## Marin Headlands and Fort Baker Transportation Infrastructure and Management Plan

Final Environmental Impact Statement

March 2009

## GOLDEN GATE NATIONAL RECREATION AREA

**FIGURE 2.3 ALTERNATIVE 3 (PREFERRED ALTERNATIVE) — ENHANCED MULTI-MODAL ACCESS (ROADS, PARKING, AND TRANSIT IMPROVEMENTS)**

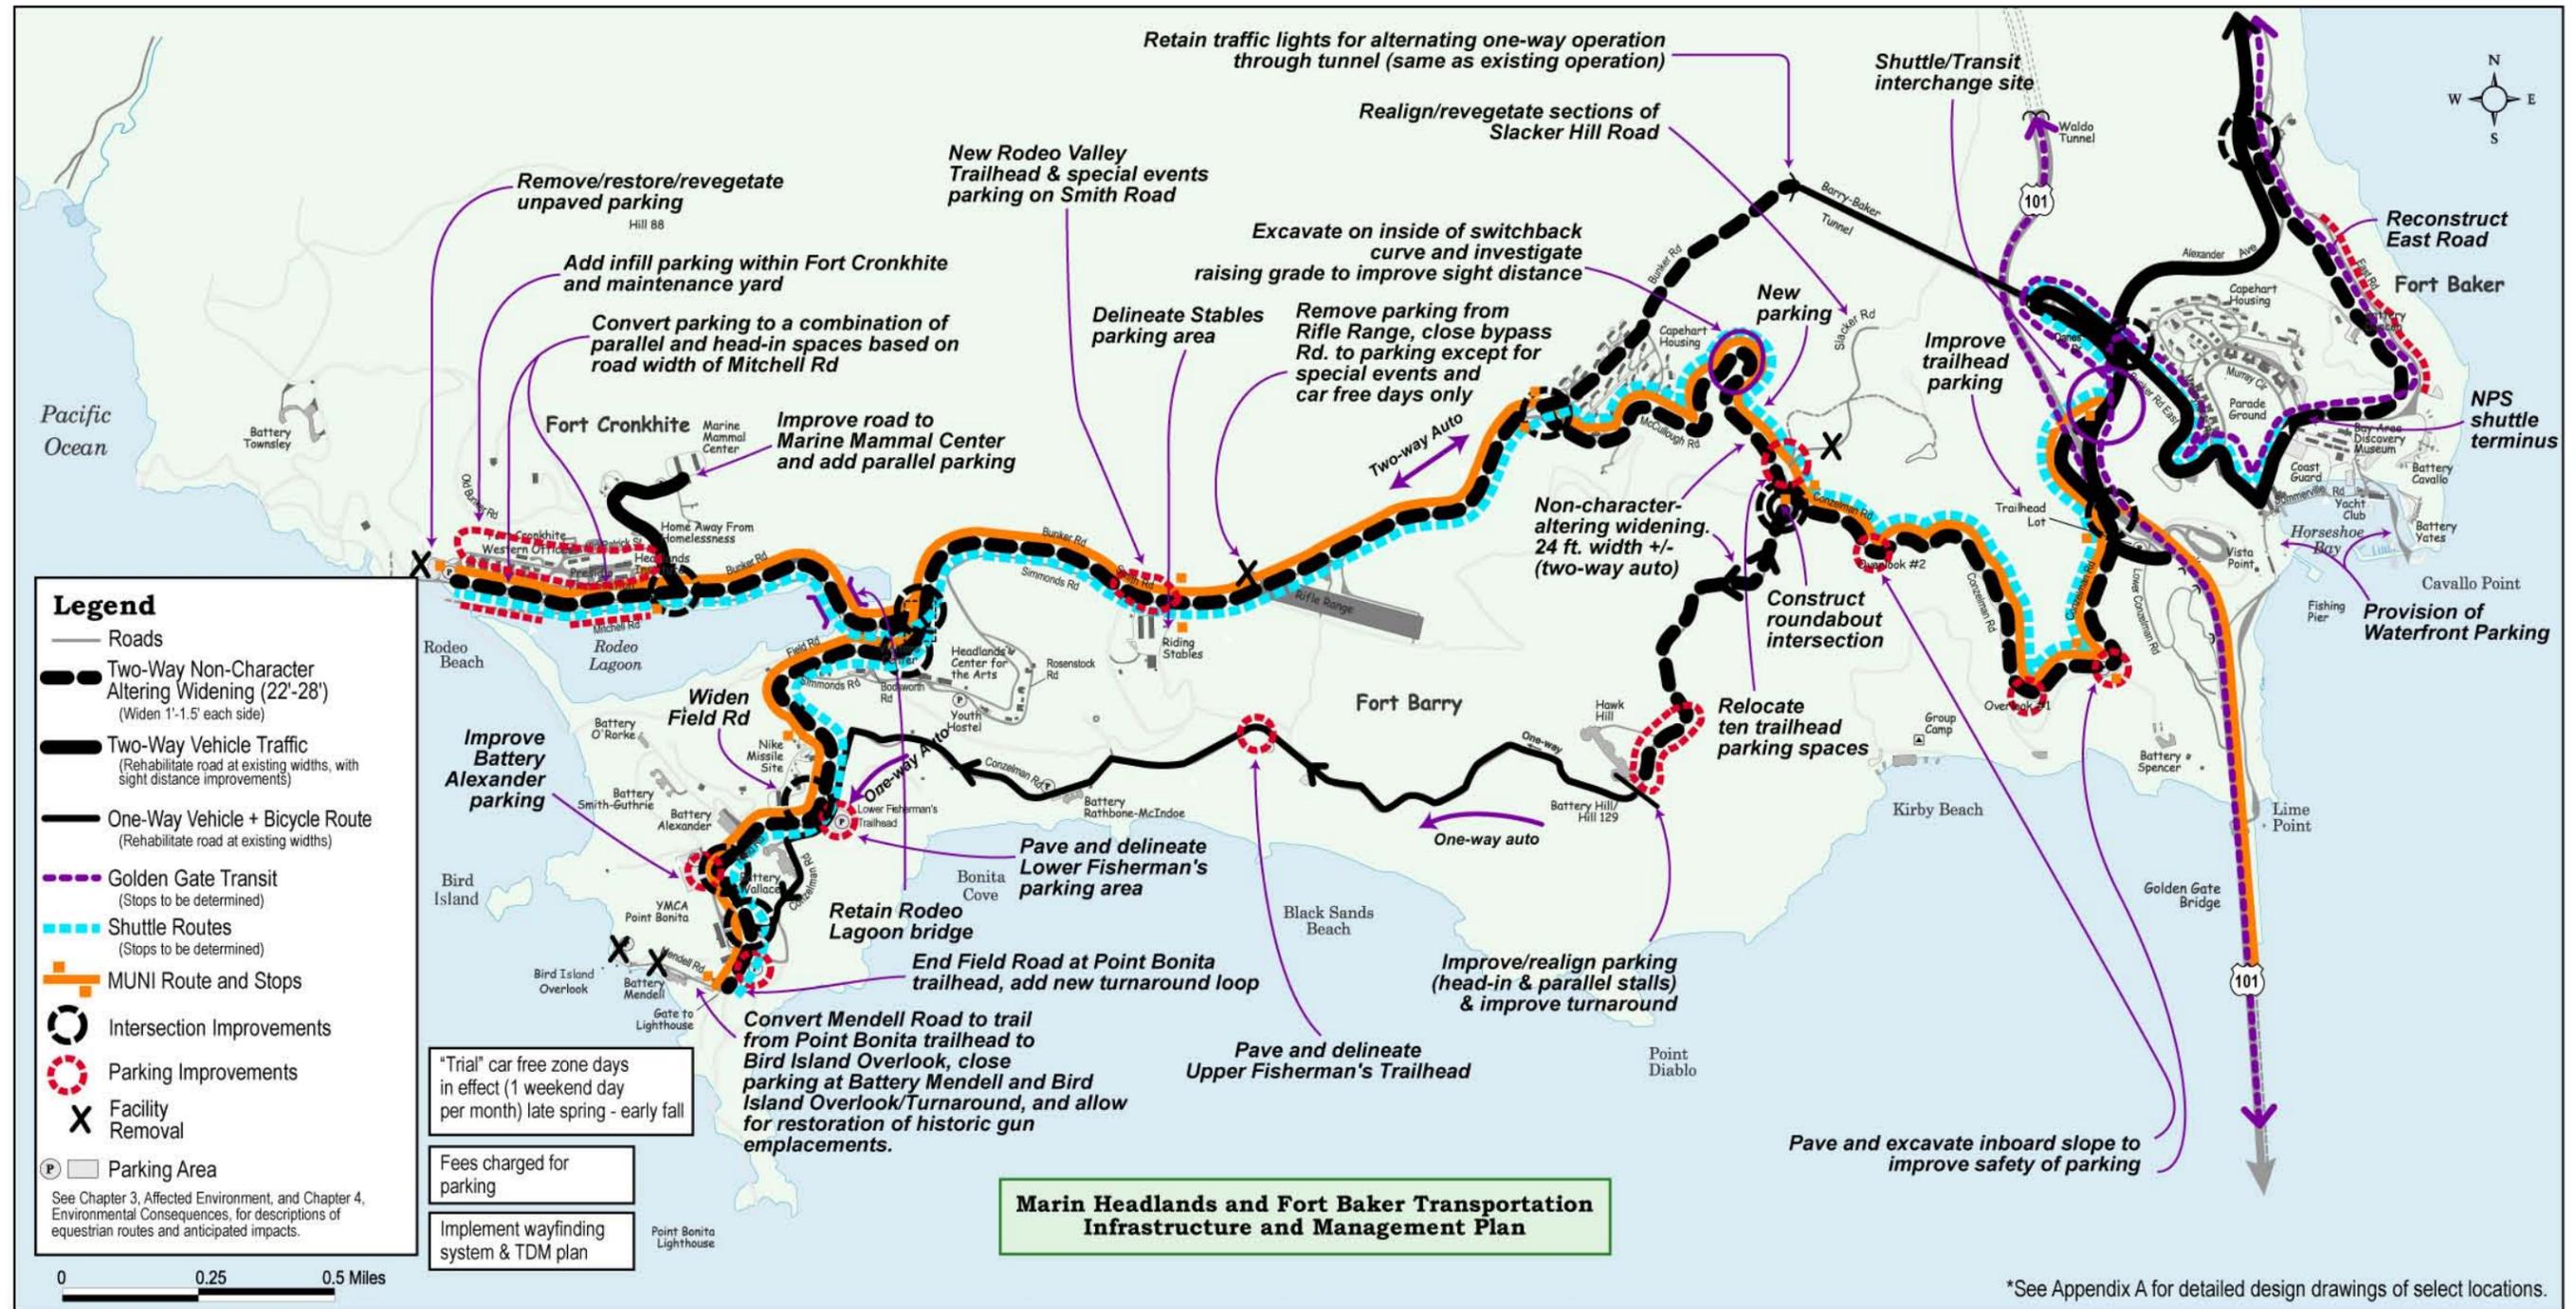
1. Section 2.5.5 describes Alternative 3 transit services and states that GGT Route 10 service on Alexander Avenue would continue with connections to other transit services at bus stops on the east and west sides of Highway 101 and with pedestrian/bicycle access at Danes Drive. However, Figure 2.3 and Table 2.1 show GGT operating on Bunker Road and East Road into Fort Baker. Further, it is not clear how connections between GGT and other services would be enabled at Highway 101 since GGT currently does not have a bus stop near Hwy. 101 in the southbound direction due to roadway conditions, and pedestrian access between the west and east sides of Highway 101 is constrained by the narrow underpass. Table 2.1 Summary of Alternatives, page 65, identifies bus stop and underpass improvements as future projects in Alternative 1 – the no-action alternative. District seeks clarification on how such apparently necessary improvements to GGNRA can be part of a no-action alternative.

In alternative 3, NPS would encourage the GGT Route 10 on Alexander Avenue to be rerouted to provide direct service to Fort Baker. Section 2.5.5 of the FEIS will be clarified for consistency with Figure 2.3 and Table 2.1, which show GGT operating on Bunker Road and East Road to provide service to Fort Baker.

**Response:** In Alternative 3, the GGT Route 10 on Alexander Avenue would be rerouted to provide direct service to the main post area of Fort Baker. Section 2.5.5 of the FEIS will be clarified for consistency with Figure 2.3 and Table 2.1, which show GGT operating on Bunker Road and East Road to provide service to the main post area.

**FIGURE 2.8 ALTERNATIVE 4 — MAXIMUM MULTI-MODAL ACCESS (ROADS, PARKING, AND TRANSIT IMPROVEMENTS)**

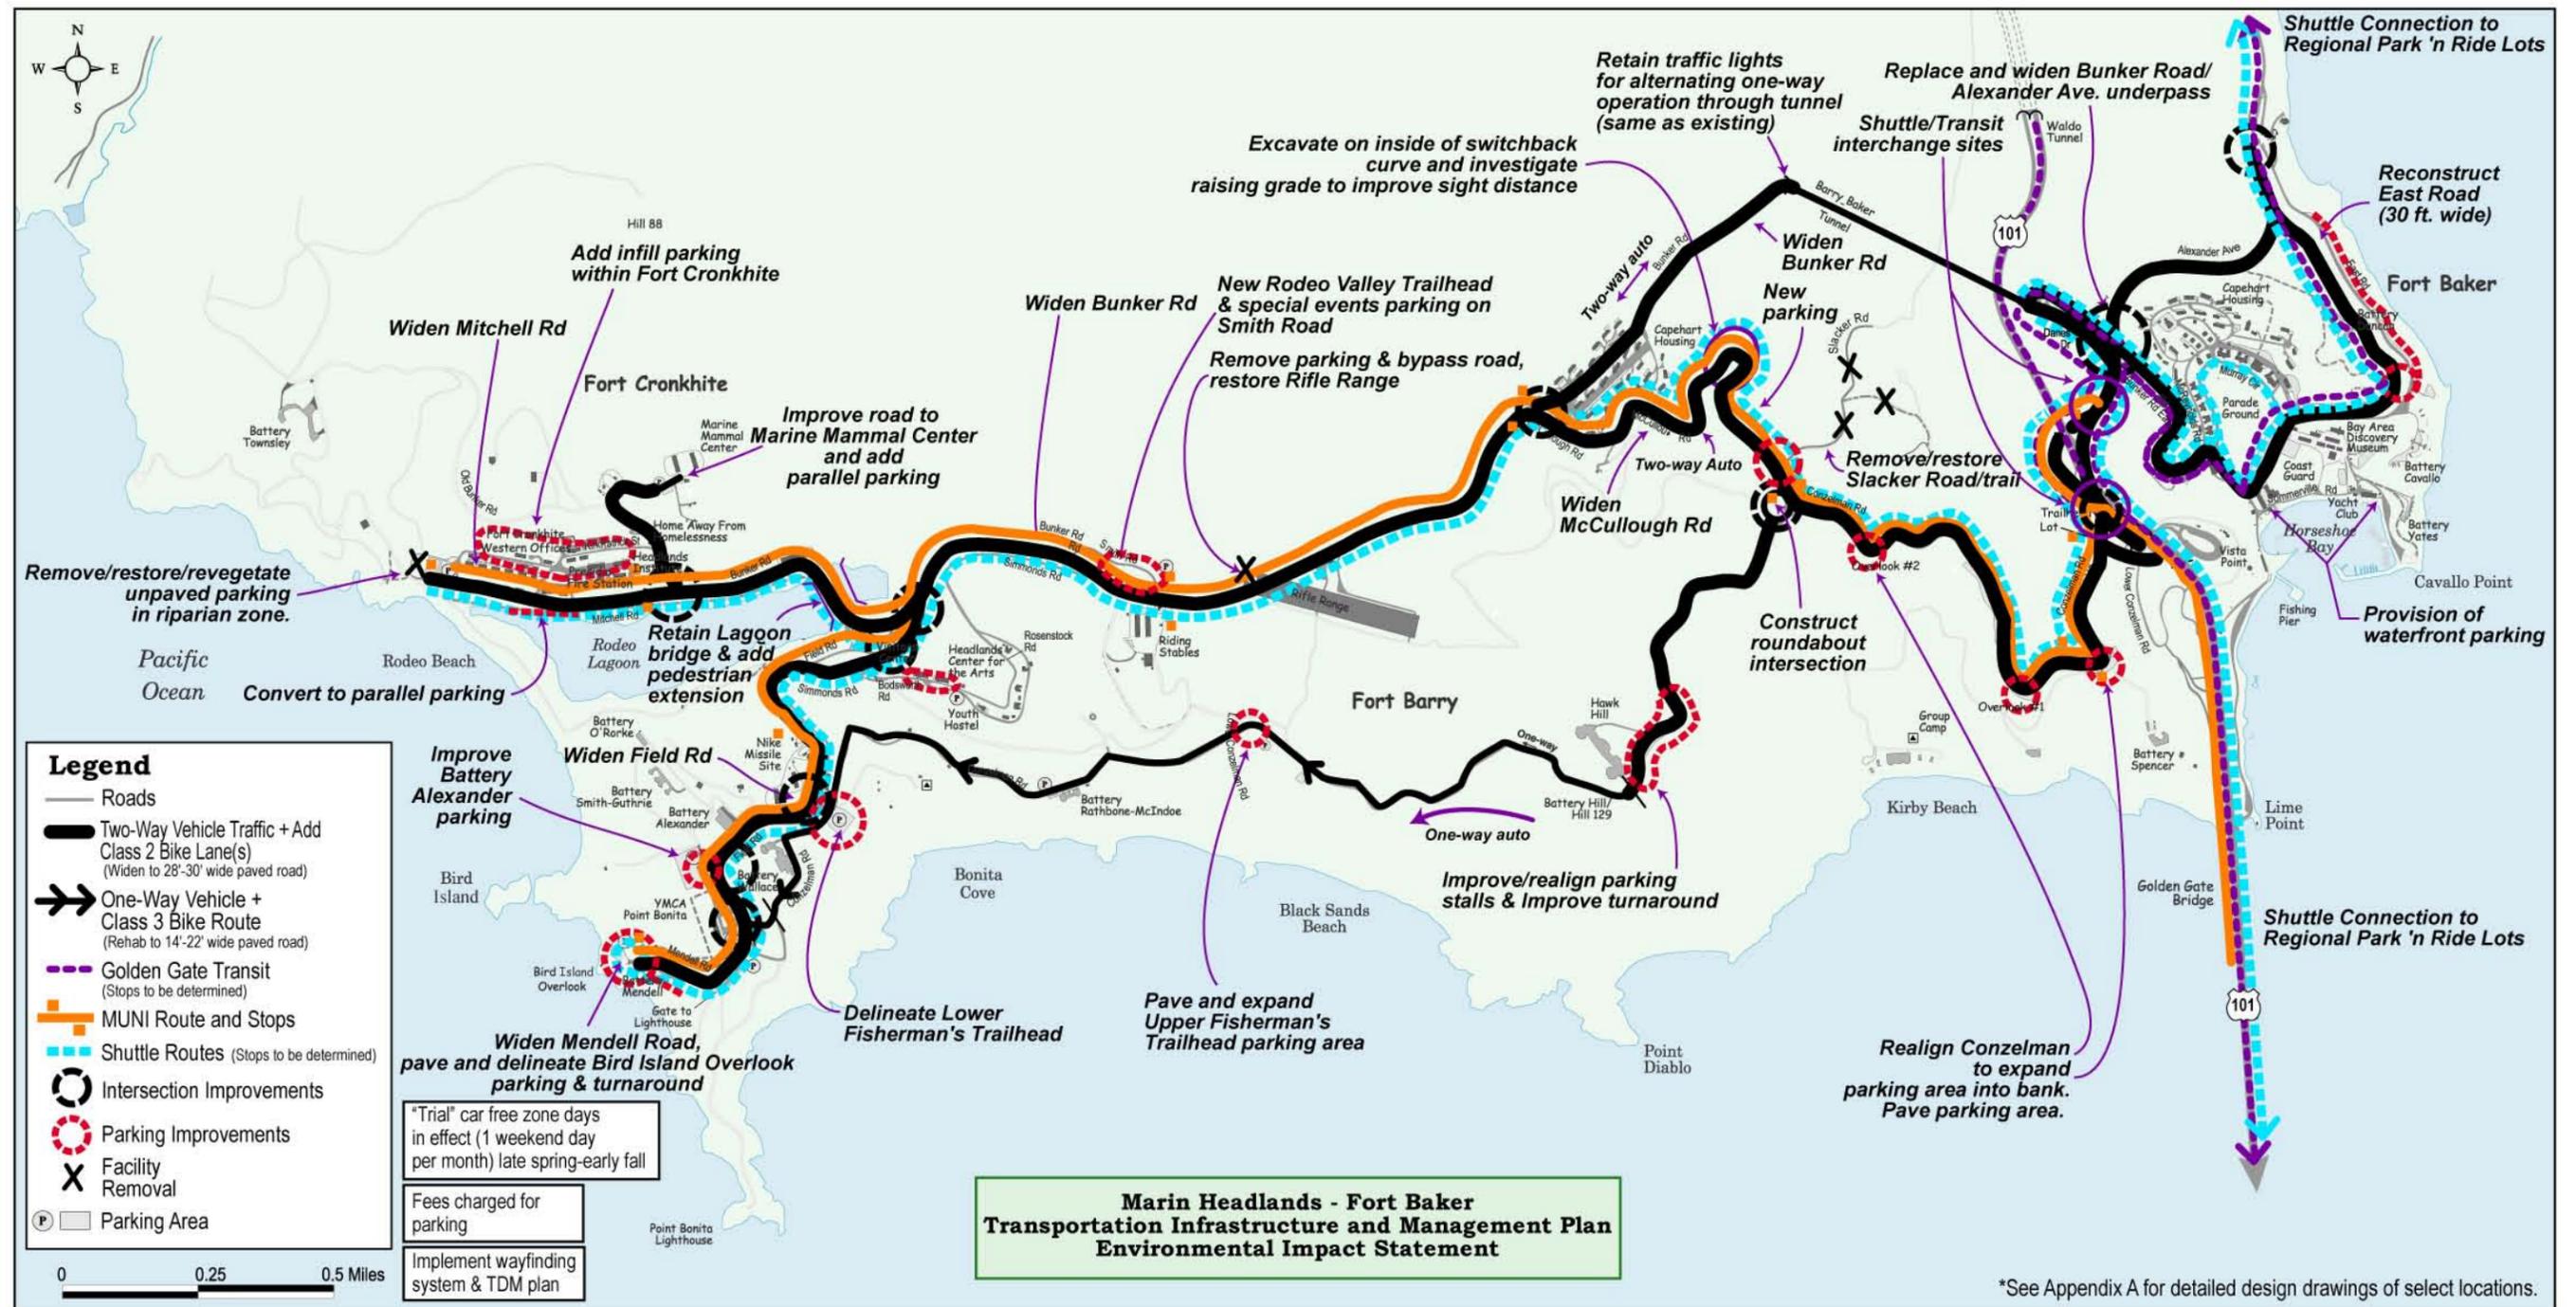
3. Section 2.7.5 describes Alternative 4 transit services. Figure 2.8 shows GGT operating on Bunker Road and East Road into Fort Baker. District staff had previously informed GGNRA staff and consultants of need for roadway improvements, such as wide lanes and standard bus stops, to accommodate GGT bus operations and bus stops at Fort Baker. Please clarify if such improvements are

| <p>included in GGNRA plans. Figure 2.8 also shows the Highway 101 transit connection locations described in Section 2.5.5 and we reiterate our related comment above.</p>  | <p>J-6 cont.</p> |

Section 2.7.5 describes Alternative 4 transit services. Figure 2.8 shows GGT operating on Bunker Road and East Road into Fort Baker. District staff had previously informed GGNRA staff and consultants of need for roadway improvements, such as wide lanes and standard bus stops, to accommodate GGT bus operations and bus stops at Fort Baker. Please clarify if such improvements are included in GGNRA plans. Figure 2.8 also shows the Highway 101 transit connection locations described in Section 2.5.5 and we reiterate our related comment above.

**FIGURE 4.2 PEAK-SEASON WEEKEND TRAFFIC VOLUMES — YEAR 2023**

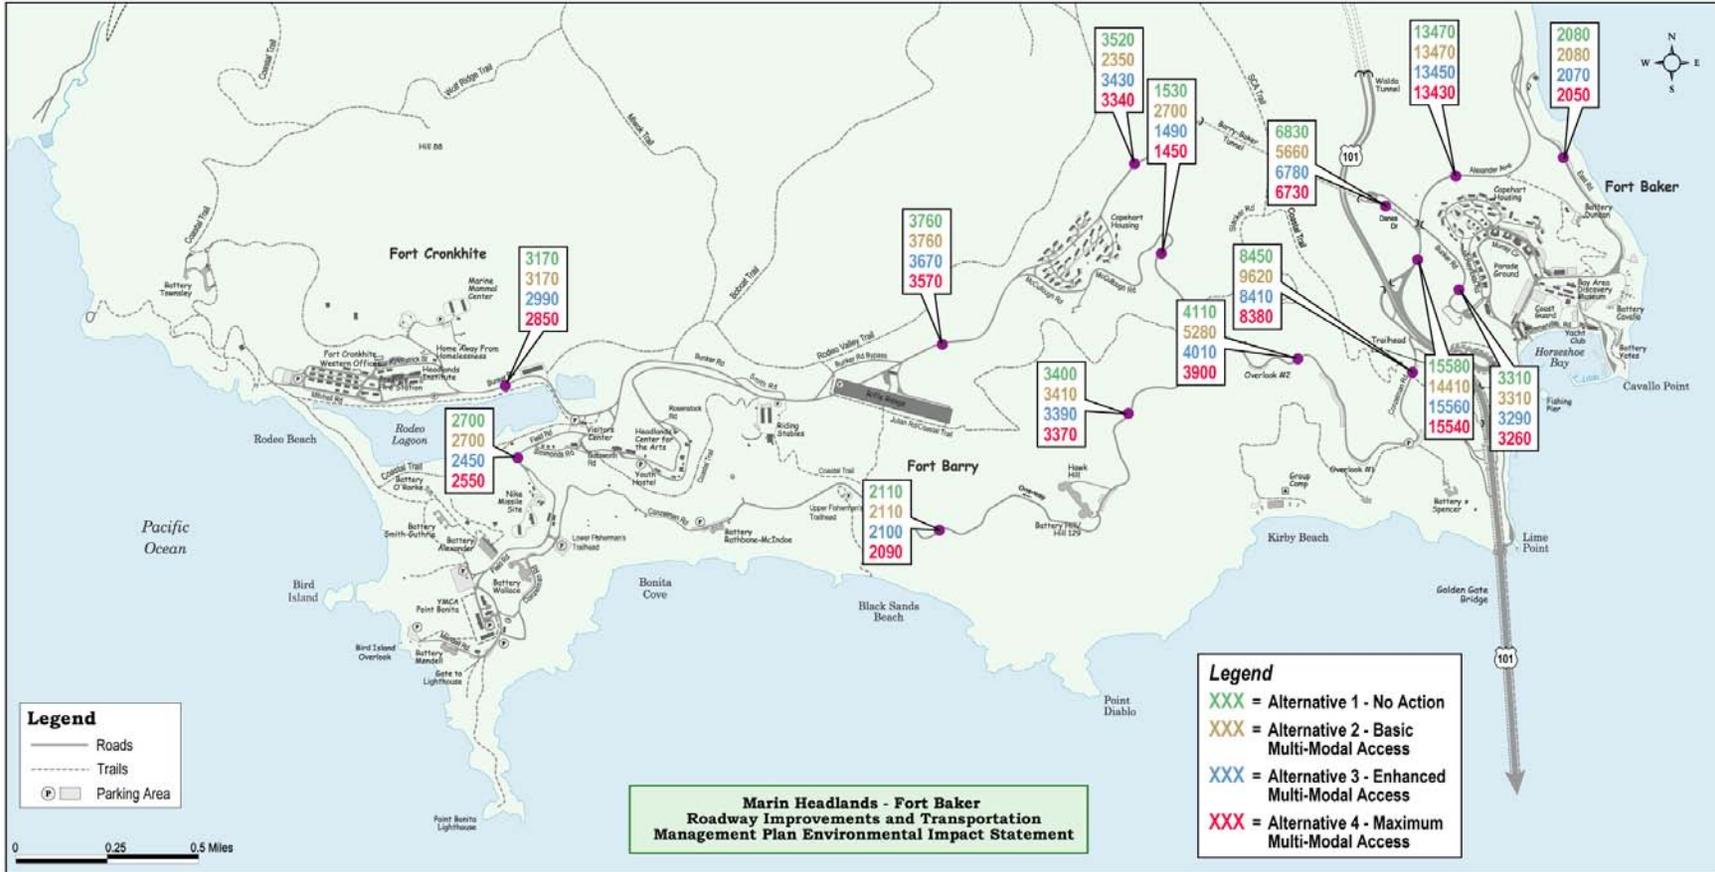
| <p>9. Section 4.2.2, Traffic, Figure 4.2 provides estimated 2023 traffic levels. LOS analysis of Alexander Avenue at Highway 101 and Danes Drive for the four alternatives is referenced without supporting data. Results for Alternatives 1 and 3 are summarized as "no change" and "negligible", while Alternative 2 notes that Alexander/Danes "could be signalized" to avoid minor adverse impacts on LOS, and Alternative 4 notes the possibility of a signal despite negligible LOS impact. District requests that detailed traffic analysis data be presented in the EIS to support findings.</p>   | <p>J-11</p>      |

Section 4.2.2, Traffic, Figure 4.2 provides estimated 2023 traffic levels. LOS analysis of Alexander Avenue at Highway 101 and Danes Drive for the four alternatives is referenced without supporting data.
